## DESIGN REVIEW BOARD

## DRB20-00826

Proposed industrial development

## Elevations

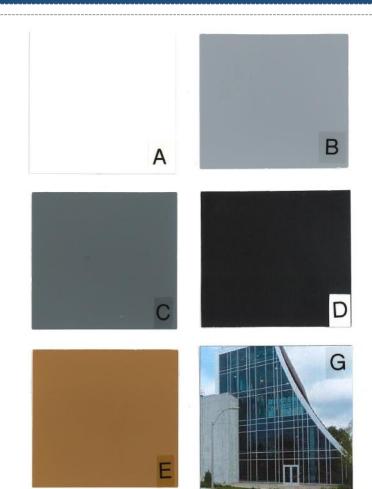
<b>√</b>	Design incorporates multiple materials		
	Wall articulation		
<b>√</b>	South Elevation		
X	North Elevation		
X	Roof articulation		
X	No more than fifty percent (50%) of the total façade may be covered with one (1) single material

- Staff is seeking guidance on the following:
  - Wall articulation (north elevation)
  - Roof articulation
  - Building material composition
- Staff welcomes any feedback
